# COUNCIL OF THE ISLES OF SCILLY

<b>PLANNING REFERENCE</b>	P/21/054/HH
<b>DEVELOPMENT</b>	Roof alteration for introduction of two dormers plus velux roof light (amended plans)
<b>PROPOSED:</b>	
<b>LOCATION:</b>	Westward Ledge, Church Road, Hugh Town, St Mary's, Isles of Scilly, TR21 0NA

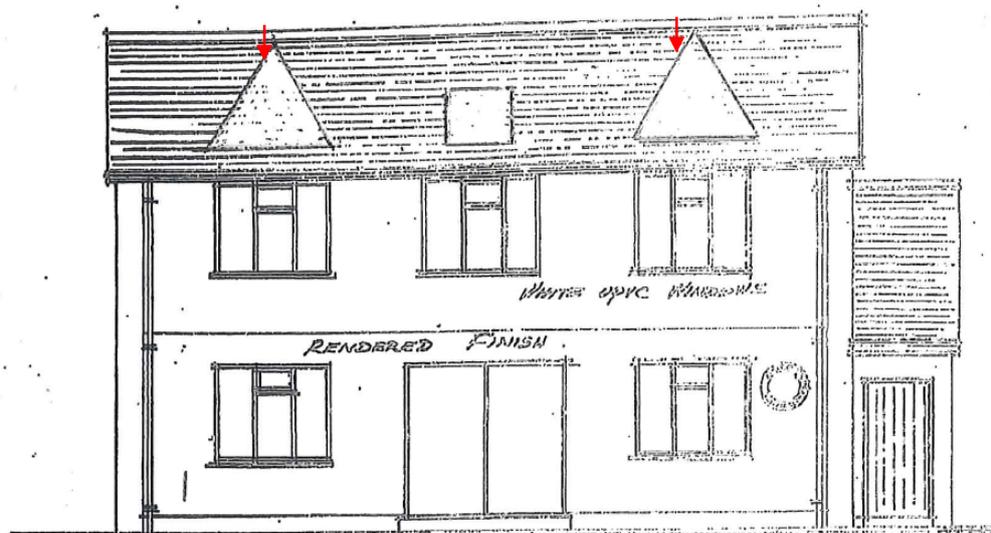
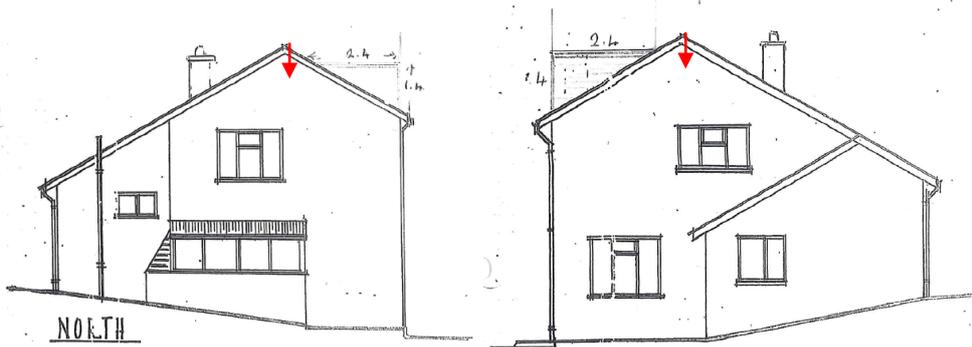
Further to the submission of the corrected amended plans, and my apologies for the delay in getting back to you. I am writing to request that you indicate which option you would like to propose, as you indicated two in your response. Because of the nature of the plans that have been edited multiple times there appears to be a degree of inconsistency between what is shown on the front elevation and what you show from the side elevation. In order to ensure the plans are consistent between the side view and the front view, please can you mark on the distances between the ridge line of the dormer and the ridge line of the main roof. So with the final version, you need to be consistent with the position of the dormers relative to the ridge line and the eaves line of the main house.

Thank you for the correction, yes, they are not dormer windows but dormer structures within the roof. I note that you confirm that the space within the roof is not for habitable purposes and that you would expect there to be a condition to restrict such a use. There does seem to be a desire to create large dormer features and I would request that you look to amend the plans to the scale as originally indicated to you of my original letter. This was not intended to show construction of the roof to the edge of the roof slope, but to align with the front wall of the house.

As noted above there needs to be accuracy and consistency between all elevations. As with building control plans, these plans need to be accurate so we can be confident on what it is we are considering. There is a big different between how you show these structures on the front elevation and how they appear from each side. The plans show a different position for each elevation. We cannot condition construction in accordance with plans that are inconsistent with one another. Please can you lower the position of the ridge of the dormer, and ensure you note the distance from the ridge line.
